**FINAL DECISION**  
**Jemena Gas Networks (NSW)**  
**Ltd**  
**Access Arrangement**

**2020 to 2025**

**Attachment 5**  
**Capital expenditure**

June 2020

**Figure 5.1 Leaks in the Newcastle Area**

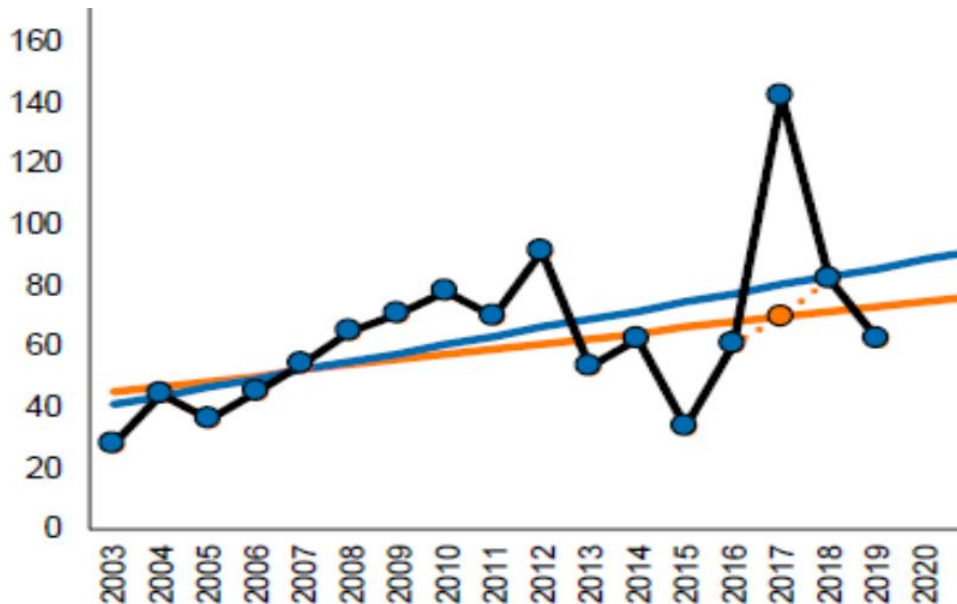
Zincara provided advice in relation to this information. Analysis by Zincara shows that there has not been any appreciable change in annual leaks since around 2009, apart from a surge in 2017. This would suggest that prioritisation for a mains replacement of the Newcastle network has not appreciably changed during that time.<sup>89</sup> JGN has not demonstrated that all of the proposed 104 kilometres of mains replacement in Newcastle is necessary to maintain and improve the safety of services.<sup>90</sup>

Figure 5.1 shows there has not been any appreciable change in annual leaks since around 2009, apart from a surge in 2017. We do not accept JGN’s argument in relation to safety risk, as JGN has been effectively managing the Newcastle assets with a similar leak profile for the last ten years.

**Figure 5.2 JGN historical relocation capex trend (\$nominal)**

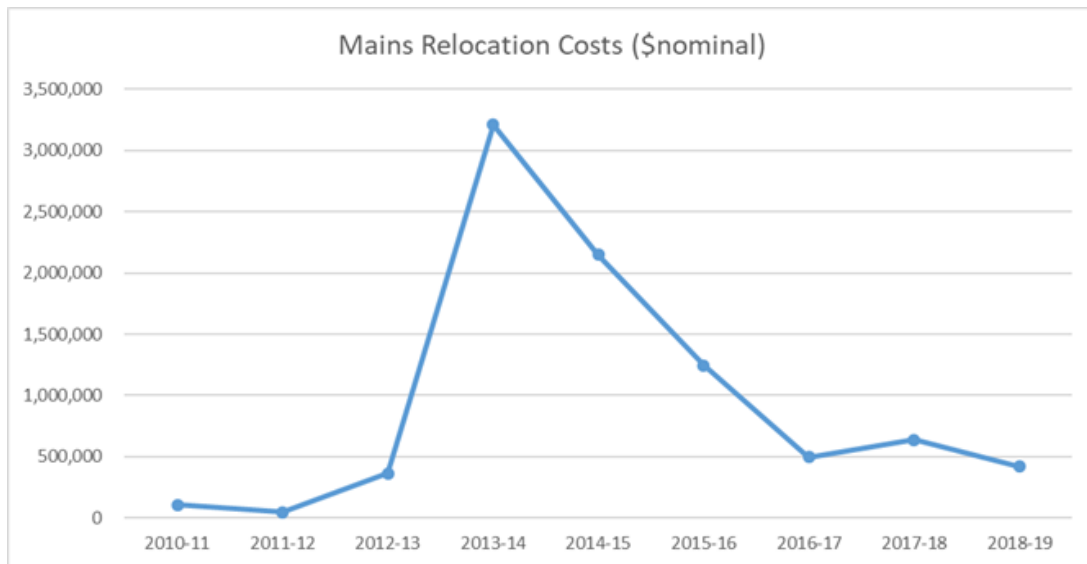
As can be seen in Figure 5.2, there was a significant spike in relocation capex for the three years from 2013–14 to 2015–16. Prior to that period, there had been some minimal relocation costs, and the three years from 2015–16 to 2018–19 shows a more consistent annual expenditure. While JGN has stated that it does not expect relocation costs to fall, it did not highlight any specific project that will cause a spike in the 2020–25 period. As the 2015–16 year is more than 50 per cent higher than the subsequent years, we consider this an outlier, which should not be included as part of the calculation to determine annual cost for the 2020–25 period.
